MFN 06-097 Supplement 1

Subject: **Supplemental Response to Portion of NRC Request for Additional Information Letter No. 76 – Instrumentation and Control – RAI Number 7.4-1**

RAI Number 7.4-1 Supplement 1

Figure ZZ-1
ESBWR DCIS Remote Shutdown Panel
Reactor Building

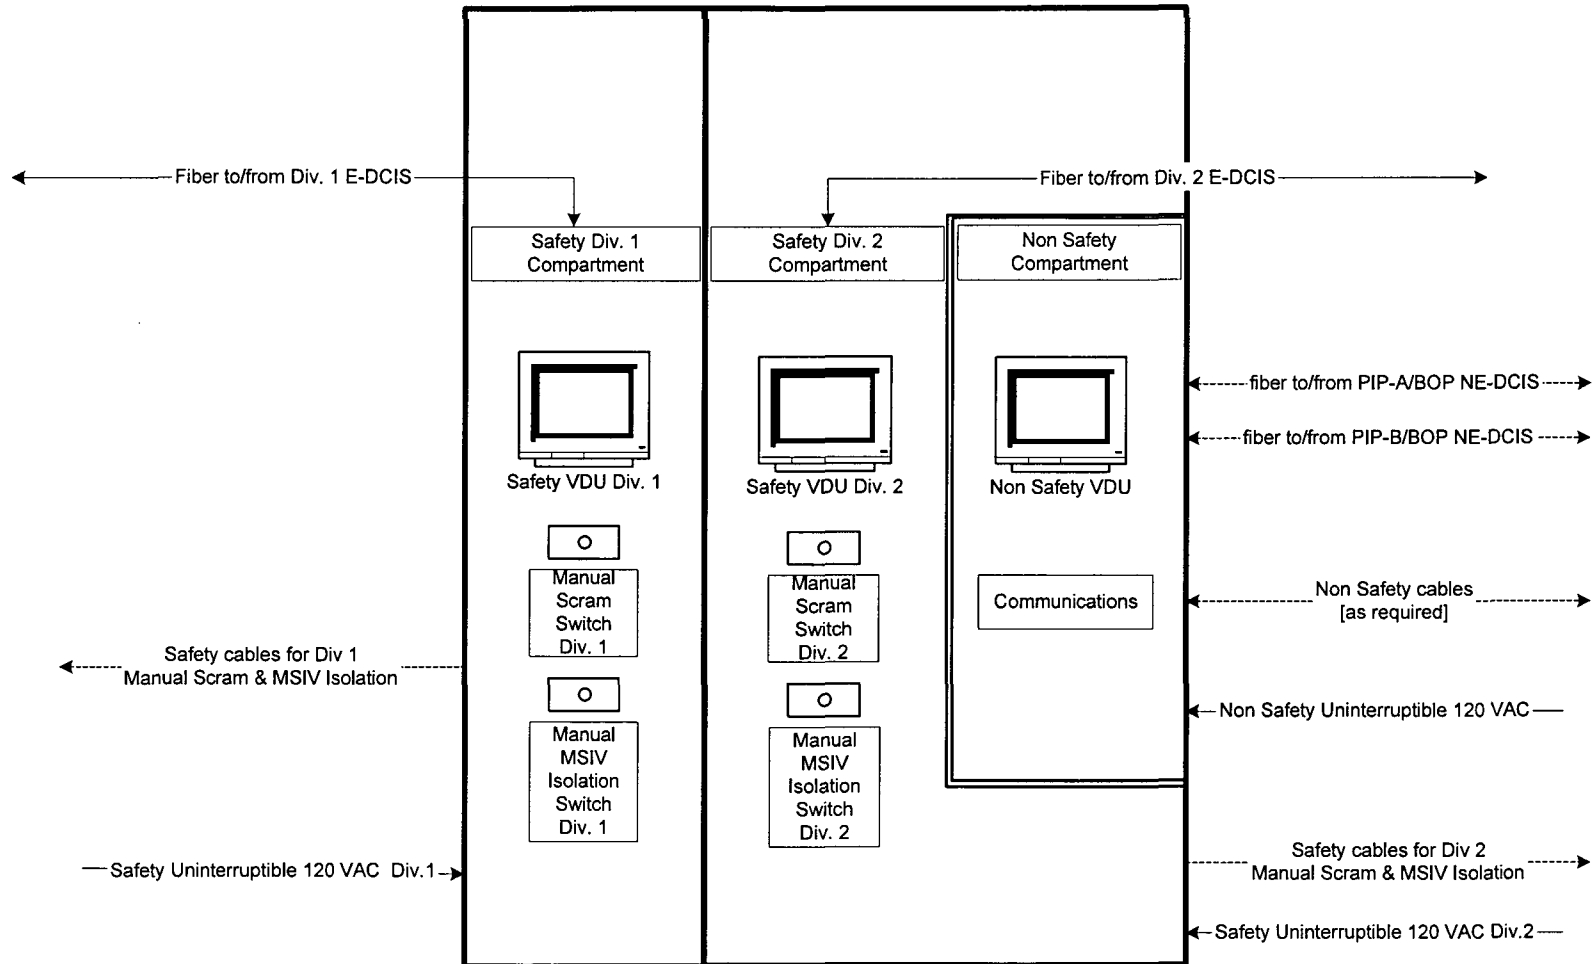
To followup Staff RAI question 7.4-1, the DCD, Tier 2, Revision 1, Section 7.4.2.2, states that the remote shutdown system (RSS) has two redundant and independent panels, each contains a safety related digital visual display unit (VDU), and a nonsafety related VDU. From these VDUs it is possible to control both safety-related and nonsafety-related systems. Please provide detailed information of RSS control capabilities and provide drawings to demonstrate the separation/isolation between safety and nonsafety systems. Also provide the design basis to qualify the VDU for safety related application. RAI question 7.4-1 specifically requested "drawings to demonstrate the separation/isolation between safety and nonsafety systems." Also, "the design basis to qualify the VDU for safety-related applications" was not specifically addressed. The DCD should be updated to include a simplified drawing and address the design basis to qualify the VDU for safety related application.

Subsequent to submission of GE's response to RAI question 7.4-1, functional design & separation requirements for a typical Remote Shutdown System (RSS) panel have been revised as shown in attached figure ZZ-1 that supersedes figure ZZ attached to GE Response to RAI question 7.4-1. The new Figure ZZ-1 schematically shows the isolation/separation between the constituent compartments of an RSS panel. Design drawings pertaining to isolation and separation will be prepared at the time of detailed design activity, and the requirements of RG 1.75 will be met.

As described in Section 7.4.2 of DCD Tier 2 Rev 2, each RSS panel has two safety-related compartments (Divisions 1 and 2) and a nonsafety-related compartment. Each safety-related compartment houses a safety-related VDU, manual scram switch, and manual MSIV isolation switch that correspond to the applicable Division. The nonsafety-related compartment with a nonsafety-related VDU remains unchanged. The two RSS panels located in rooms at two different areas in the reactor building are identical and redundant. Division 1 and 2 VDUs on the RSS panels are connected to E-DCIS through the safety-related networks that individually serve the Division 1 and 2 VDUs at the MCR. Similarly, the nonsafety-related VDU on each RSS panel is connected to the nonsafety-related network that serves the nonsafety related VDUs at the MCR. Therefore the RSS VDUs have all the control/display capabilities as the corresponding VDUs at the MCR. Isolation between E-DCIS and NE-DCIS as described in Sections 7.9.1 and 7.9.2 of DCD Tier 2 Rev 2 applies to isolation between safety-related and nonsafety-related components of RSS. The Human Factors Engineering (HFE) processes described in Chapter 18 of DCD Tier 2 Rev 2 will determine the design details of the MCR and RSS display/controls.

The safety-related VDUs will be qualified and tested in accordance with 10 CFR 50 Appendix B requirements and meet, as a minimum, the applicable sections of IEEE Std 603-1991 pertaining to information display, IEEE Std 323-2003 for environmental qualification (as endorsed by DG-1142), and IEEE Std 344-1987 for seismic qualification.

Section 7.4 of DCD Tier 2 Rev 3 will be revised to include the figure attached to this response.
